April 2017
FL724A-Q
NHTSA #16V-666 (Non-School Buses)
NHTSA #16V-664 (School Buses)
SECOND REVISED NOTICE

Subject: ICU3S Instrument Cluster Hydraulic Brake Telltale

Models Affected: Specific Freightliner Business Class M2 vehicles and Freightliner Custom Chassis S2 bus and B2 (Thomas Built Buses C2 Saf-T-Liner) school bus chassis manufactured March 3, 2015, through September 8, 2016.

Fig. 1, "Park" Telltale - Replace ICU3S

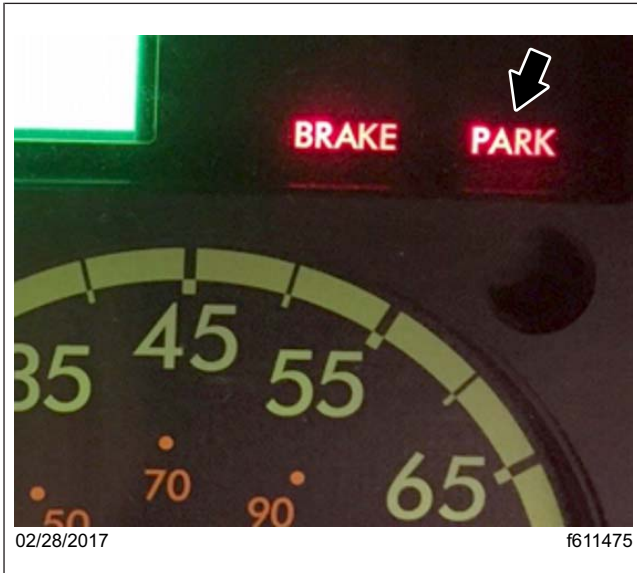
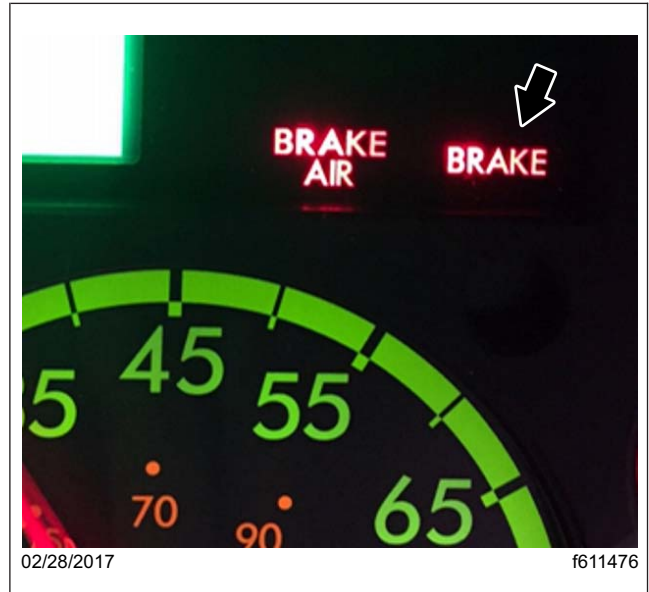
On certain hydraulic braked vehicles with ICU3s instrument clusters, the telltale for a brake malfunction says "PARK" instead of "BRAKE," as required by FMVSS 101 (Controls and Displays) and FMVSS 105 (Hydraulic and Electric Brake Systems). If "PARK" is illuminated instead of "BRAKE," the driver may not be aware there is a brake malfunction that could lead to a reduction or loss of braking, resulting in a possible vehicle crash.

1. Check the base label (Form WAR259) for a completion sticker for FL724 (Form WAR260) indicating this work has been completed. The base label is usually located on the passenger-side door, about 12 inches (30 cm) below the door latch (trucks) or over the driver's window (buses). If a completion sticker is present, no work is needed. If a completion sticker is not present, proceed to the next step.
2. Park the vehicle, shut down the engine, and apply the parking brakes. Chock tires.
3. During the bulb check at key-on, inspect the telltales on the ICU3S (affected telltales will be illuminated for three seconds). See **Fig. 1** and **Fig. 2**

If the ICU3S has a "Park" telltale, continue with the next step.

If the ICU3S has a "Brake" telltale, no further work is needed. Clean a spot on the base label (Form WAR259), write the recall number, FL724, on a red completion sticker (Form WAR260), and attach it to the base label.

The instrument clusters will be inspected and replaced with clusters displaying the correct warning as needed.
